*Third Preliminary Consultation*  
**MONTGOMERY COUNTY HISTORIC PRESERVATION COMMISSION**  
**STAFF REPORT**

<b>Address:</b>	10933 Montrose Avenue, Garrett Park	<b>Meeting Date:</b>	10/14/2020
<b>Resource:</b>	Contributing Resource (Garrett Park Historic District)	<b>Report Date:</b>	10/7/2020
<b>Applicant:</b>	Doug Mader, Architect	<b>Public Notice:</b>	9/30/2020
		<b>Tax Credit:</b>	N/A
<b>Review:</b>	3 <sup>rd</sup> Preliminary Consultation	<b>Staff:</b>	Michael Kyne
<b>Case Number:</b>	N/A		
<b>PROPOSAL:</b>	Building alteration

**10933 Montrose**

Fig. 2: Previous first floor plan for the proposed front porch addition.

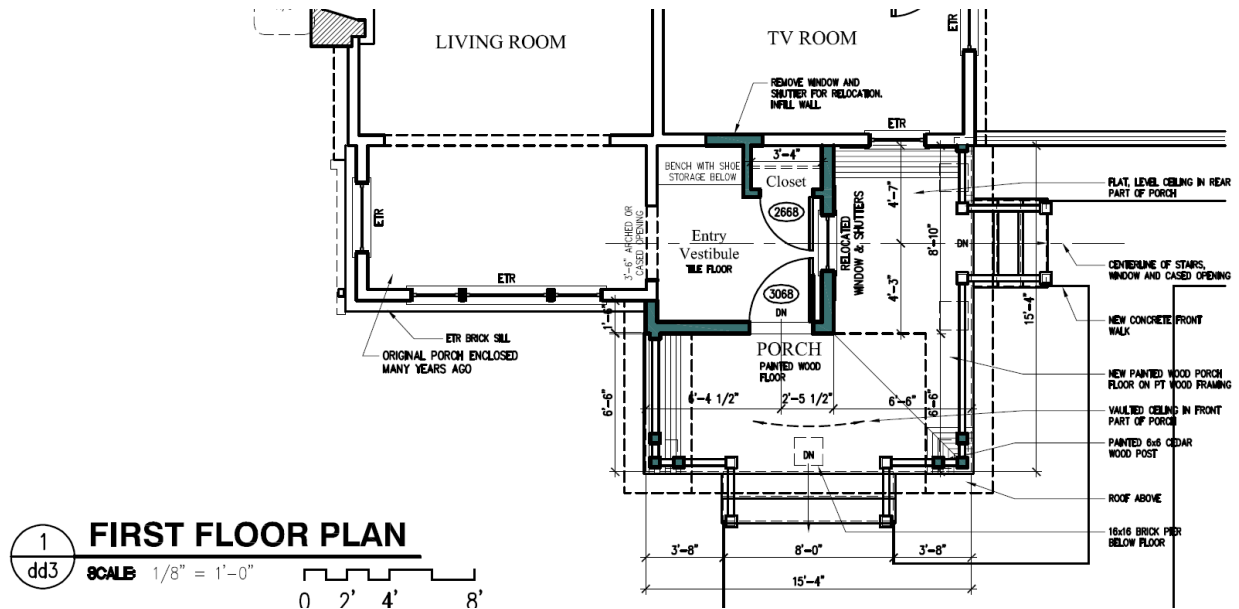
- As previously proposed, the front porch addition was a total of 15'-4" W x 15'-4" L, including a 8'-10" W x 8'-10" L vestibule.
  - As revised, the front porch addition is 15' W x 6'-10" L.

- The proposed front porch addition no longer projects forward of the existing enclosed front porch.
- The vestibule is no longer incorporated into/enveloped by the proposed front porch.

Staff is generally supportive of the proposed front porch addition, as revised. In retaining the outline of the existing enclosed front porch, the applicants have responded to the Commission's previous concerns regarding the preservation of the original building façade. The proposed front porch no longer projects forward of the existing enclosed front porch. Instead, it is 8" shorter than the existing enclosed front

porch, with the existing being 7'-6" L and the proposed being 6'-10" L. This alleviates staff's concern that the proposed front porch addition is not clearly subordinate to the existing features at the front of the house. Additionally, the applicants have removed the awkward/overly complex condition that was created with the vestibule being incorporated into/enveloped by the proposed front porch.

Fig. 3: Current first floor plan for the proposed front porch addition.

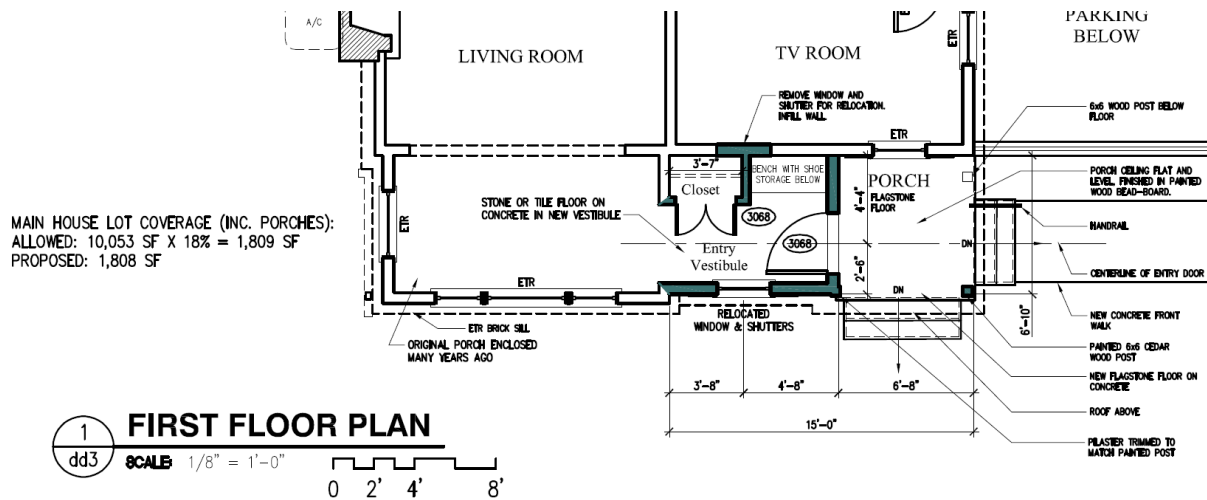
- As revised, the vestibule separates the existing enclosed front porch from the proposed front porch addition.
  - This preserves the outline of the front gable of the existing enclosed front porch.

- Several roof forms have been proposed for the front porch addition, including:
  - A shed roof.
  - A front gable (preferred).
  - A south (right) side gable.

- As revised, does the proposed front porch addition continue to alter character-defining features of the subject property and/or surrounding streetscape contrary to *Standards #2* and *#9*, or is it a compatible alteration?
- What is the preferred option for the proposed front porch roof form (shed, front gable, or side gable)?
  - Staff notes that the applicants' preferred option is the front gable; however, the Commission previously stated that two gables at the front is incompatible with the streetscape.
